# RENESAS TECHNICAL UPDATE

| THEME                        | SH7760 type number change due to logical modification. |         | Classification of Information | 1. Spec change<br>2. Supplement of Documents<br>3. Limitation of Use<br>④. Change of Mask<br>5. Change of Production Line |                |   |
| PRODUCT NAME                 | HD6417760BP200D<br>HD6417760BP200DV                    | Lot No. | Reference Documents           | SH7760 hardware manual Rev 1.0 (ADE-602-291)  | Effective Date |   |

Figure 1. Modification for Figure 25.4 in Hardware Manual Rev 1.0

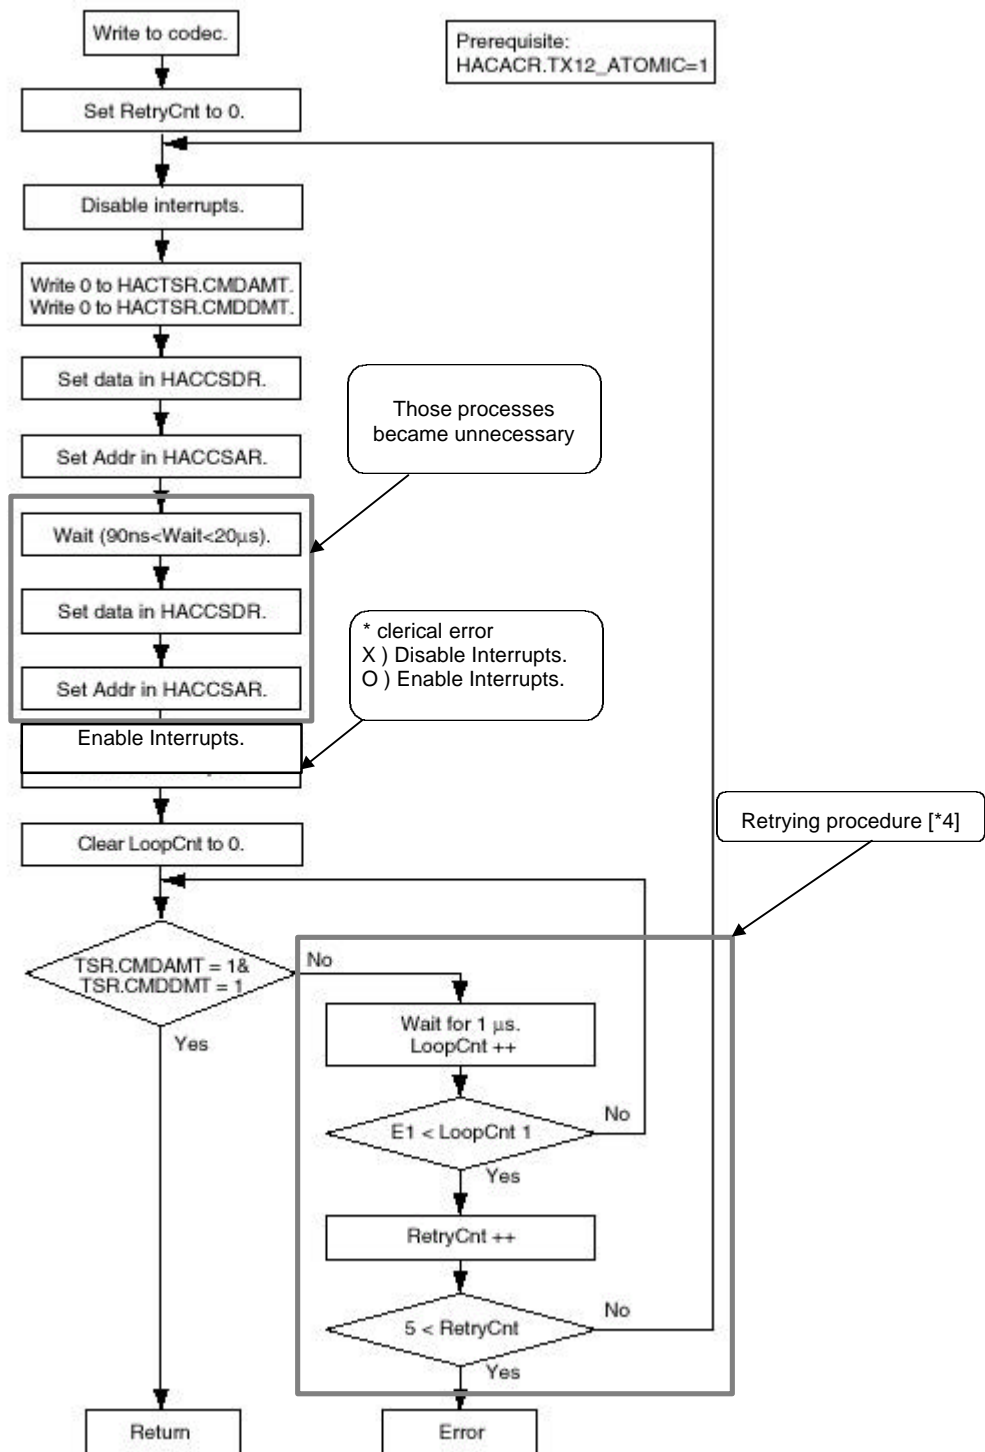
Write a codec register address to HACCSAR twice with an interval of 100ns(\*3)

HD6417760BP200AD/ADV : There is no need to apply this restriction. Please see Figure 1 and 2.

(\*4) : Some CODEC devices may not complete accessing CODEC register within 1 slot time.  
In this case, please execute this retrying procedure.
